NUCLEAR ENERGY INSTITUTE

**SUBJECT:** Response to Questions on Addendum 2 to EPRI Performance  
Prediction Methodology Software, Version 2.0

**Responses to NRC Comments on  
Addendum 2 to EPRI TR-103237-R2**

Figure 1. Determination of Zero Offsets for Valve #24

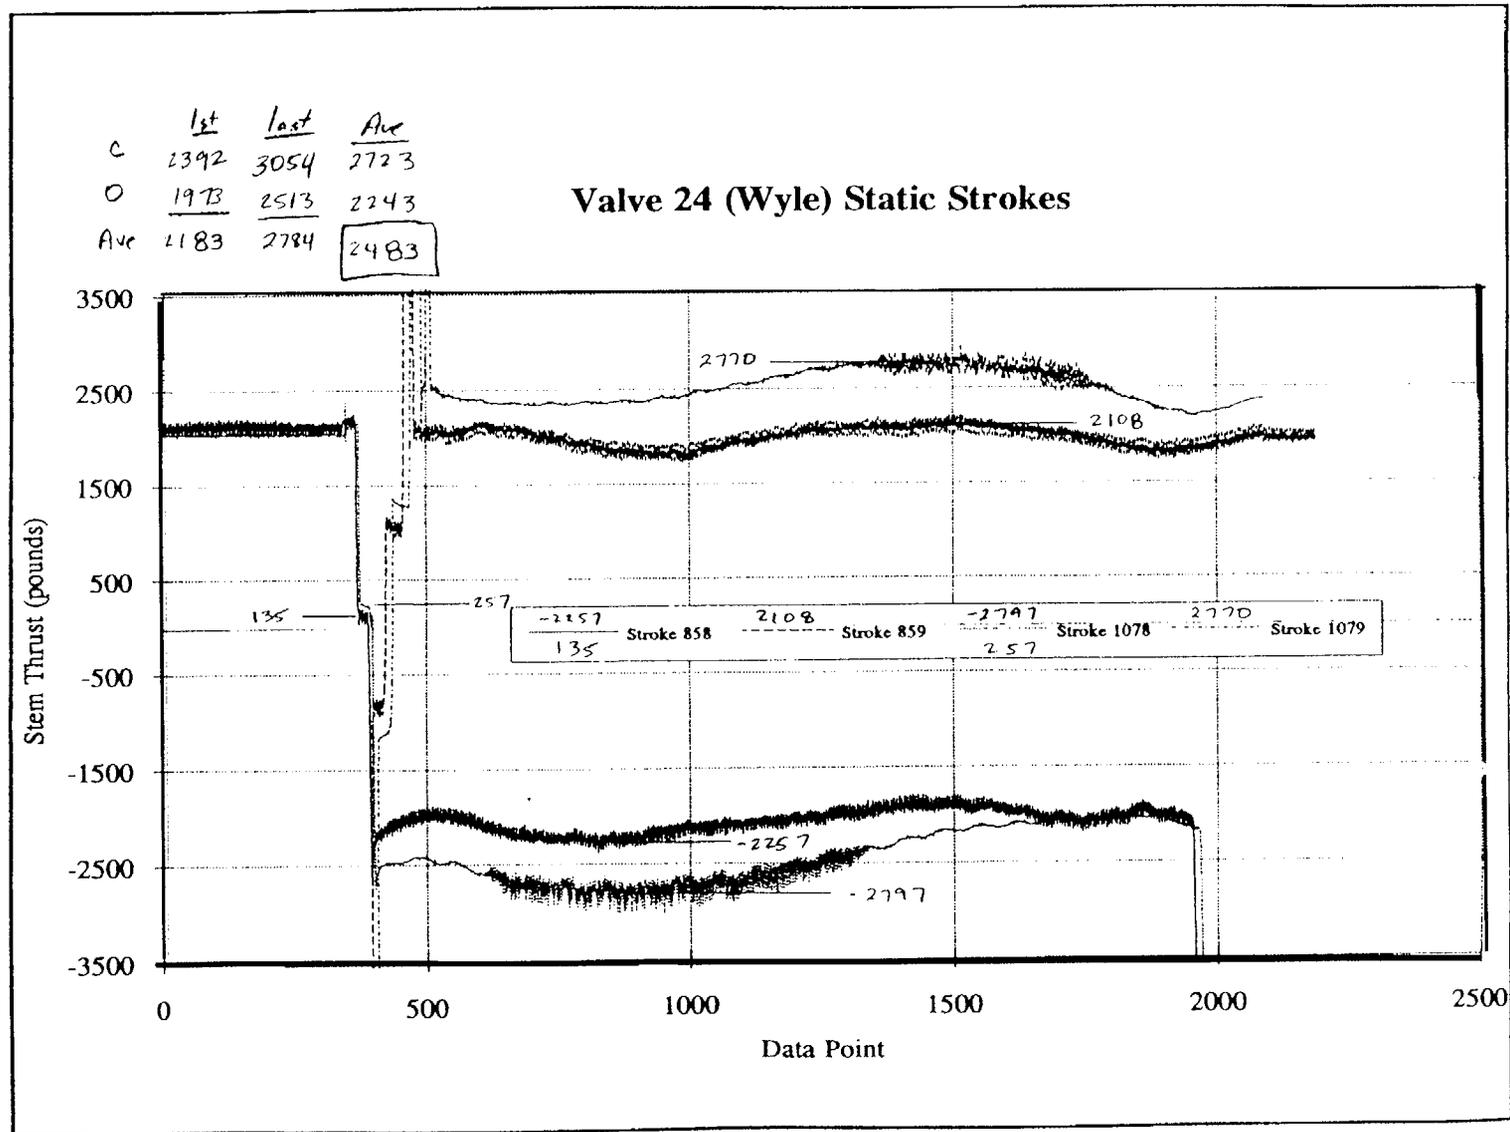
Explain why certain data in Table 1 of Appendix B to EPRI Topical Report TR-103237, Addendum 2, are different from the original test data in previously published EPRI test reports. For example, see the data in EPRI TR-103674-V9P1, "EPRI MOV Performance Prediction Program - High Pressure Cold and Hot Water Blowdown Facility Test Report, Volume 9, Part 1: Test Results for MOV #24."

We assume this comment refers to the term  $F_{\text{measured}}$  (maximum measured stem thrust) listed in Table 1 of Appendix B of TR-103237-R2, Addendum 2. Values in Table 1 are taken from EPRI TR-103229 and MPR Calculation 140-078-TW14 for solid and flexible wedge gate valves. These values may differ from values presented in the Wyle flow loop test reports (e.g., EPRI TR-103674-V9P1) because of adjustments to account for zero offsets in the data. During the EPRI MOV Program, we performed a detailed analysis of the static test data for each valve to determine if there were zero offsets in the data that should be considered when evaluating the data. For some valves, we found that zero offset adjustments were needed. MPR Calculation 140-81-TW2 determines the zero offsets from the static test data, and MPR Calculation 140-078-TW14 applies the zero offset adjustments to the maximum measured thrust for each valve stroke. The Figure 1, taken from MPR Calculation 140-81-TW2, shows the evaluation of static test data for Valve #24 (strokes performed at Wyle, not at Siemens). As shown, the zero offset for the first static closing stroke performed was 135 pounds, and the zero offset for the last static closing stroke was 257 pounds. Accordingly, in MPR Calculation 140-078-TW1, a zero offset adjustment of 196 pounds (the average of 135 and 257) was used for all Valve #24 strokes performed at Wyle. Therefore, values of measured stem thrust listed in TR-103229 and Addendum 2 to TR-103237-R2 for Valve #24 are 196 pounds higher than shown in TR-103674-V9P1.

Preconditioning Plot for Valve #1

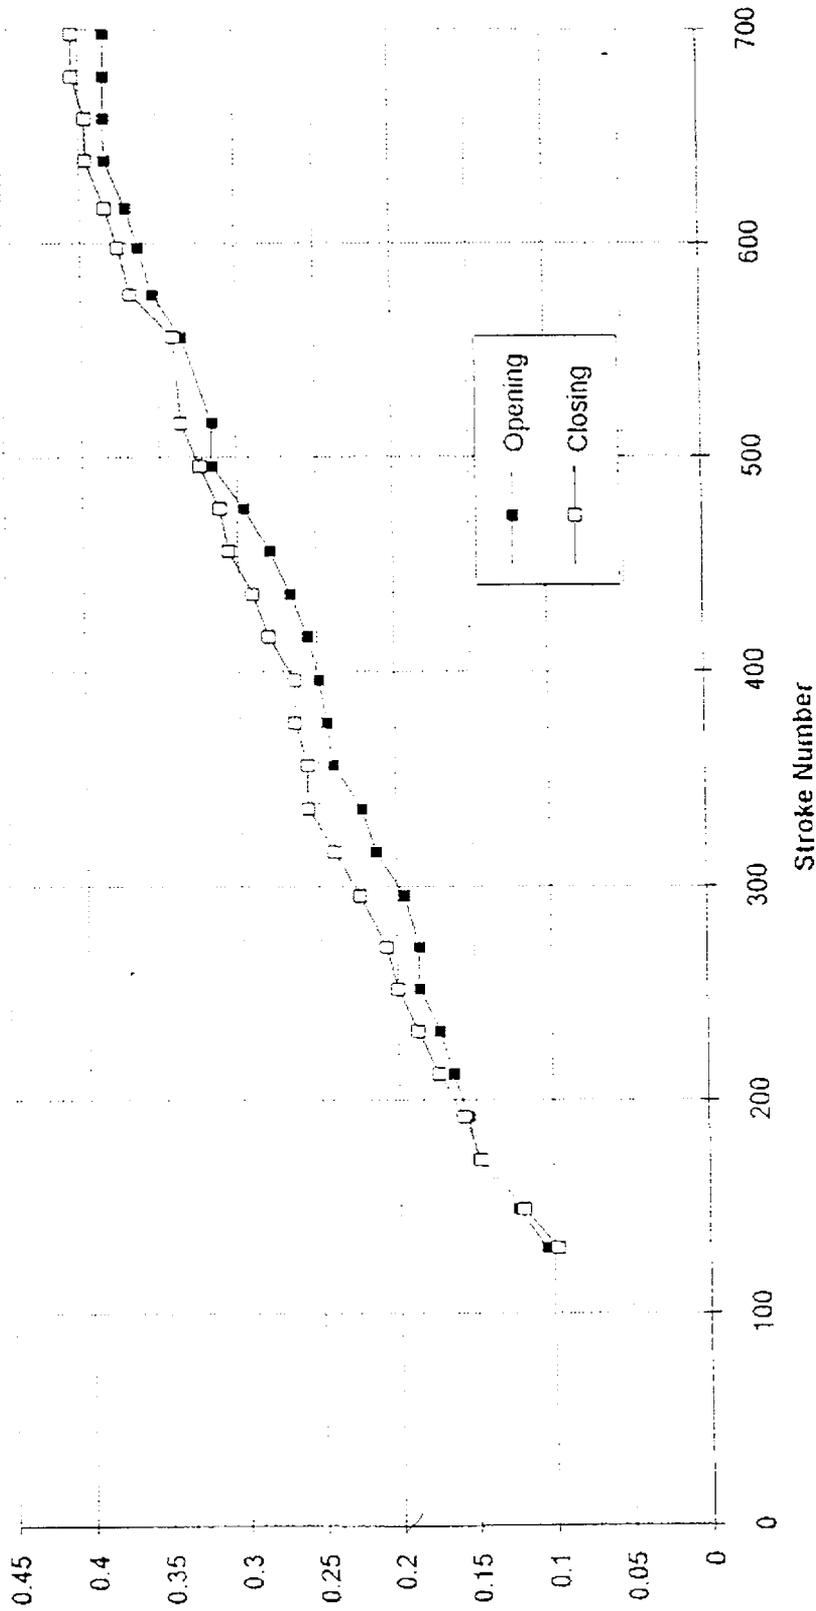
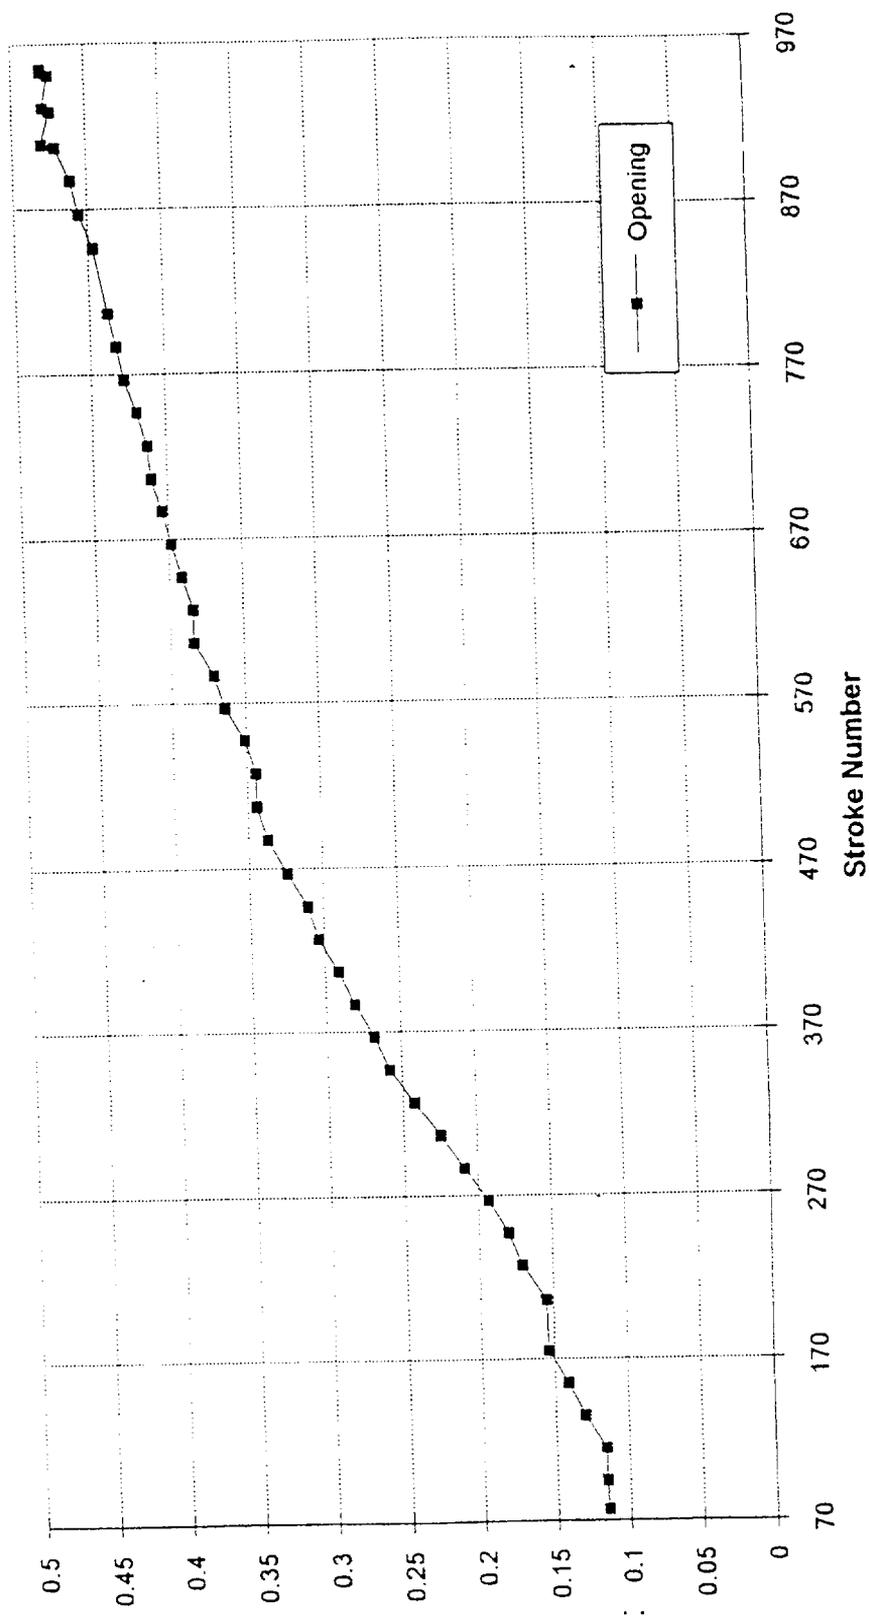
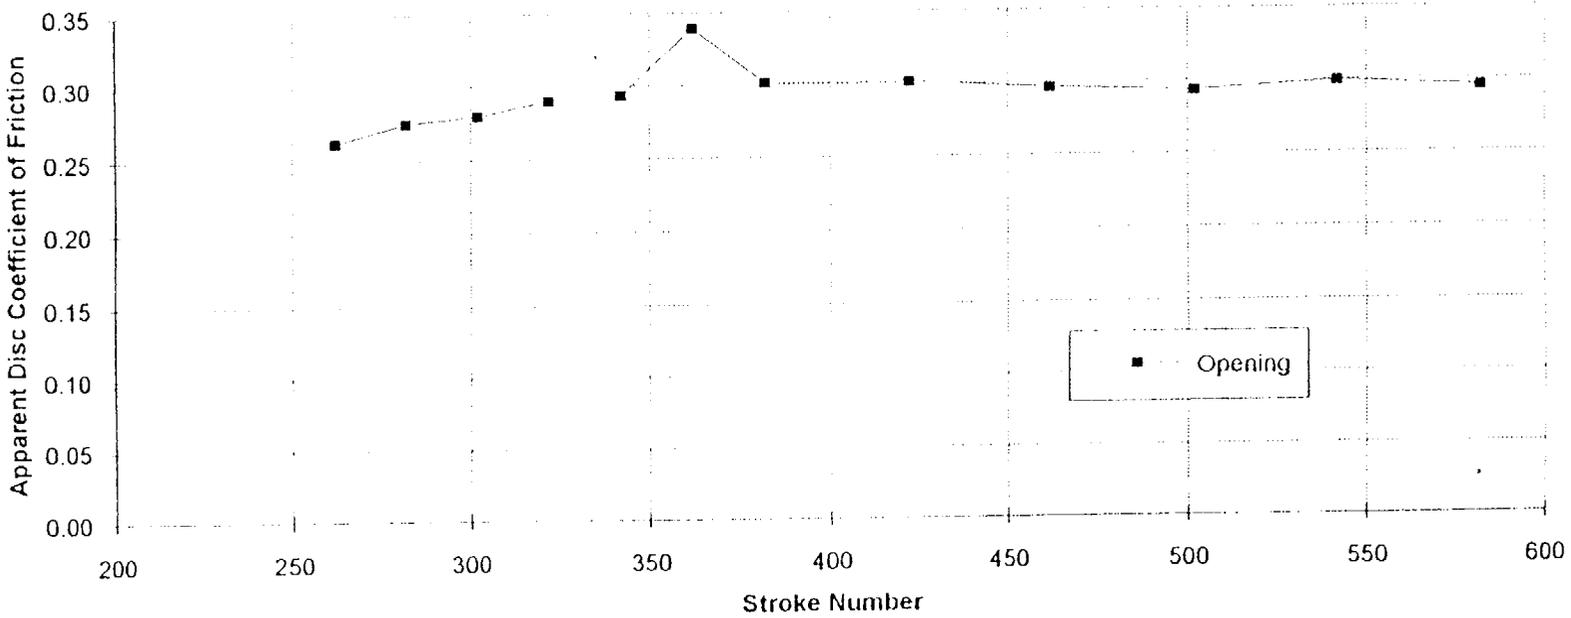
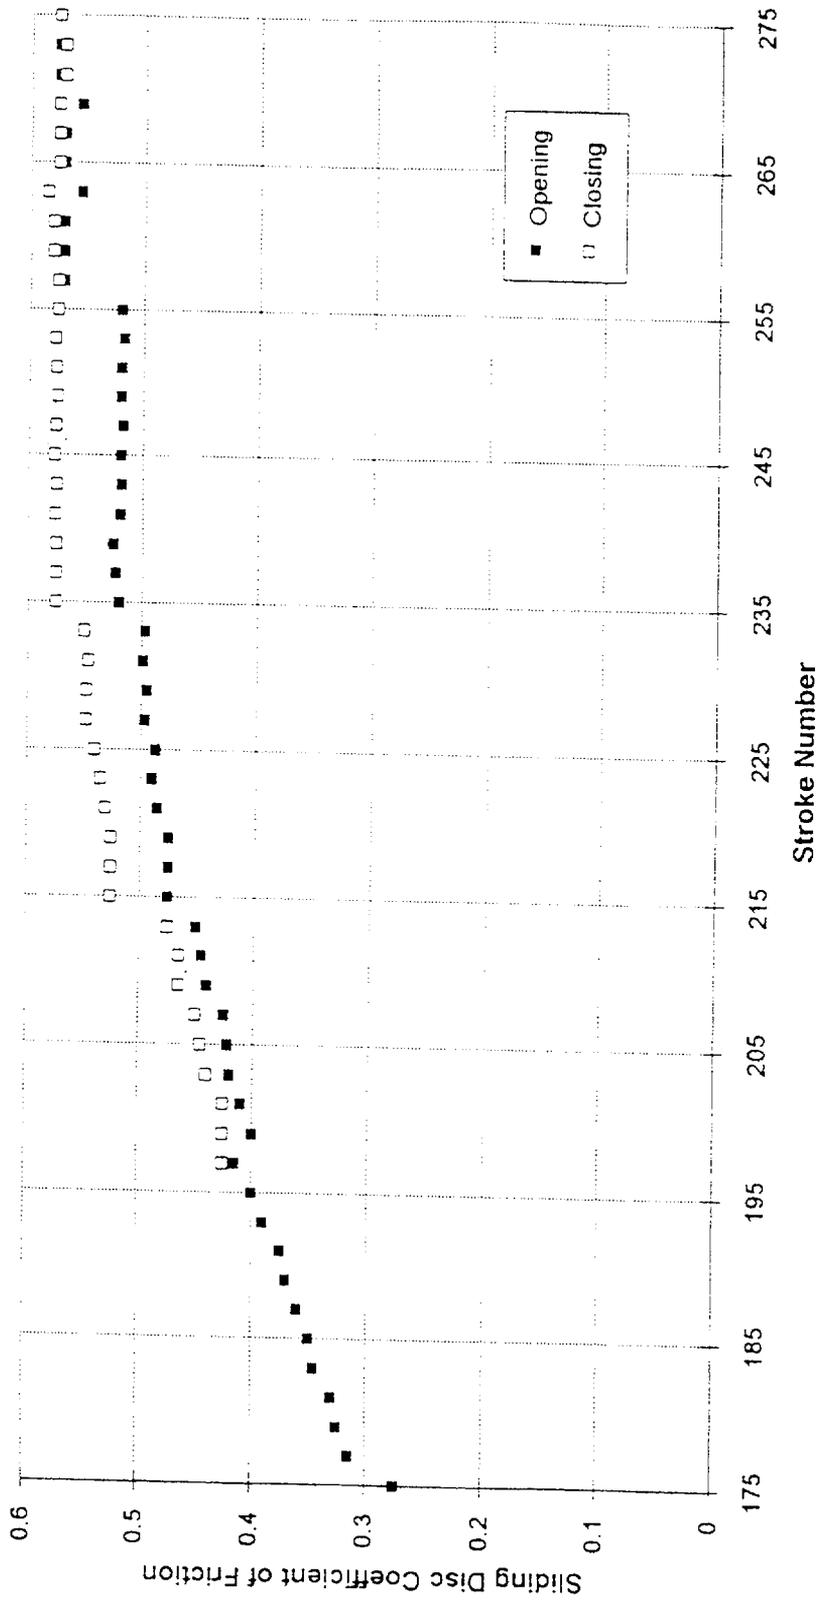
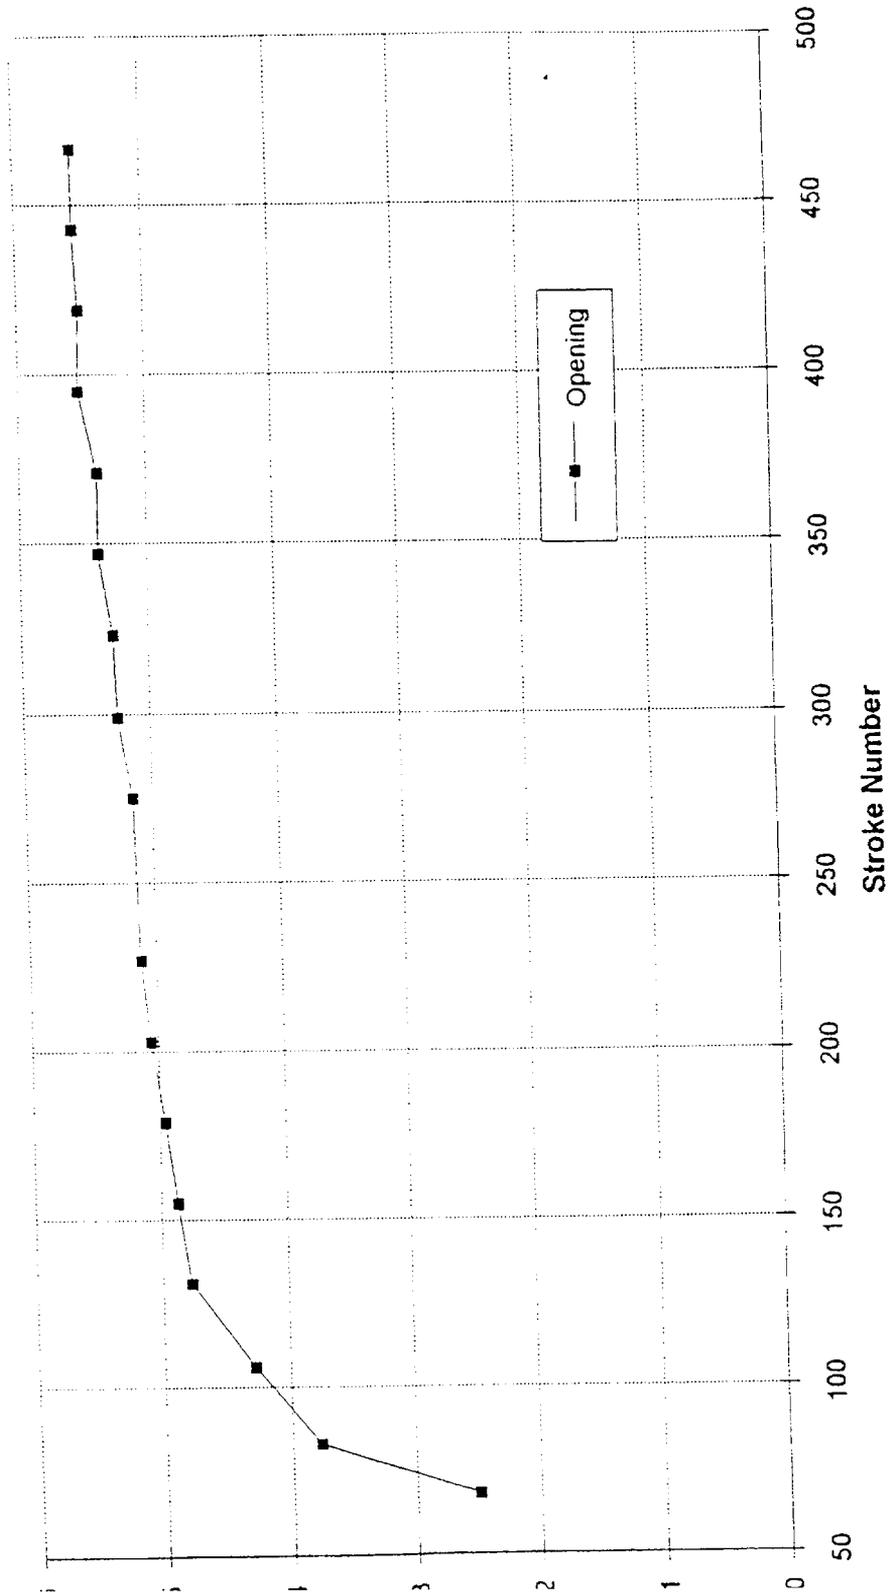
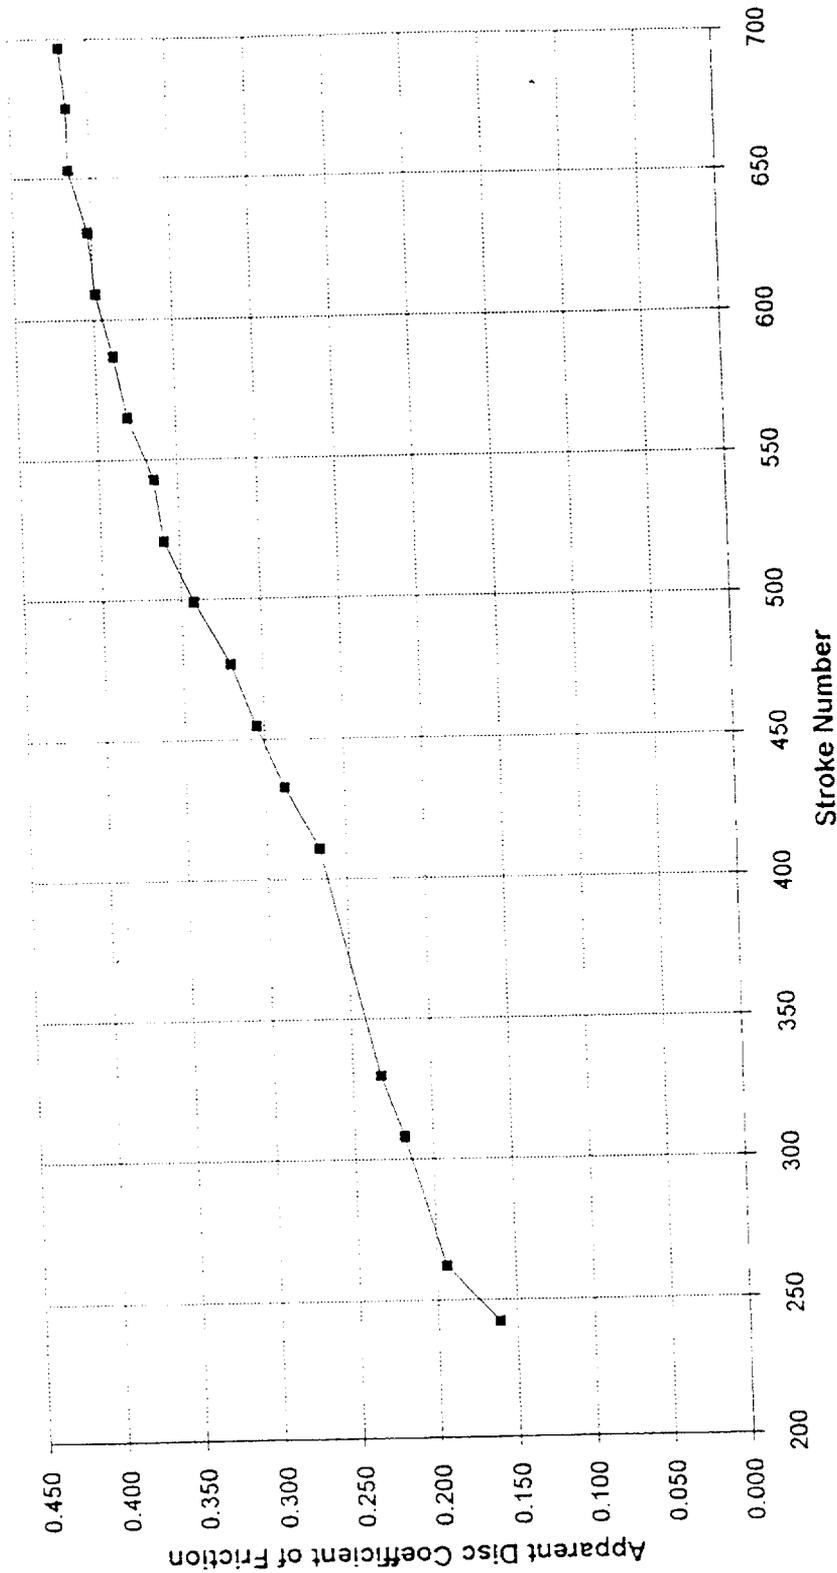
The Electric Power Research Institute (EPRI) indicated during the NRC staff review of the EPRI Motor-Operated Valve (MOV) Performance Prediction Methodology (PPM) that the scope of the valves to be included in the EPRI valve testing program was not intended to constitute a statistical database, but rather was selected to provide a reasonable validation of the EPRI MOV PPM. Explain the basis for applying the Thrust Uncertainty Method described in Addendum 2 of EPRI Topical Report TR-103237 (and the specific test data used in its support) to all gate valves within the scope of the EPRI MOV PPM.

EPRI Topical Report TR-103237, Addendum 2, assumes that the EPRI MOV PPM thrust predictions for gate valves are conservative. However, the overall test data obtained by EPRI (including data used to support the Thrust Uncertainty Method) indicate low to moderate friction coefficients for the test valves. Further, low loading conditions applied to the valves during testing might result in significant scatter in the test data. Explain the basis for the assumption that the EPRI test valves were fully preconditioned in light of this information.

The Wyle flow loop test reports include plots of measured disk-to-seat COF versus stroke number for the preconditioning strokes (attached) and measured apparent disk-to-seat COF versus stroke number for the valve flow tests. The table below summarizes the information in these plots for the 14 gate valves used to determine the average predictions ratios in the Thrust Uncertainty Method.

- With the exception of MOV #29, each test valve received at least 90 preconditioning strokes (and most received more than 400). It is unlikely that many nuclear plant MOVs have been stroke as many as 90 times with DP or flow.

- For all valves except MOV #6, the range of COFs for the flow tests was consistent with the final precondition COF. This observation supports the conclusion that the seat preconditioning was maintained between the preconditioning strokes and the flow tests. Only two strokes of MOV #6 (both cold water) were used in determining average prediction ratios. If these two strokes were eliminated from this evaluation, the average prediction ratio for cold water strokes would increase from 0.697 to 0.704. This difference is judged negligible. Note that in most cases, the range of apparent COFs for the flow tests is higher than the final COF for preconditioning. This result is expected for two reasons. First, the preconditioning strokes were performed at 100% DP and some of the flow loop tests were performed at lower DPs; Stellite COF is typically higher at low DPs. Second, there are affects other than seat friction that may be included in the apparent COFs for the flow tests, for example, stem bending and the Bernoulli effect for opening strokes.
